Issue	**1**
Factory ID	**26329**
Date of Issue	**22-Apr-2026**

Fashion Knits

Structural Safety Inspection Report

Pakistan Accord Initial Safety Inspection Report

Figure 2.3 - Plan showing location of the area

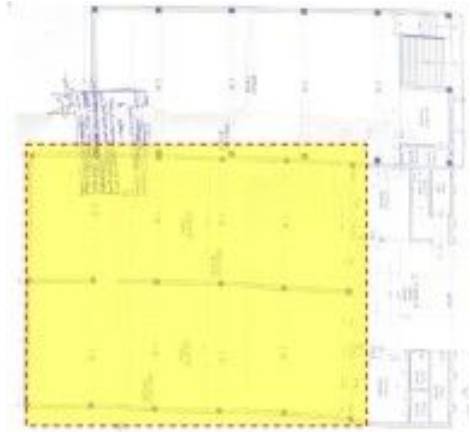
This refers to the exposed rebars on the roof of main building, where the rebars were corroded because of being exposed to the atmosphere. This corrosion can lead to reduction in the capacity of the rebars overtime. F-202604-064910

Timeline	Remediation Plan
Medium Term CAP-0076809	Building Engineer to inspect areas with exposed rebars and protect it from the weathering effects, also propose the remedial solution to further reduce the effect of corrosion and present to Pakistan Accord for review.
Longer Term CAP-0076810	Implement the remedial works.
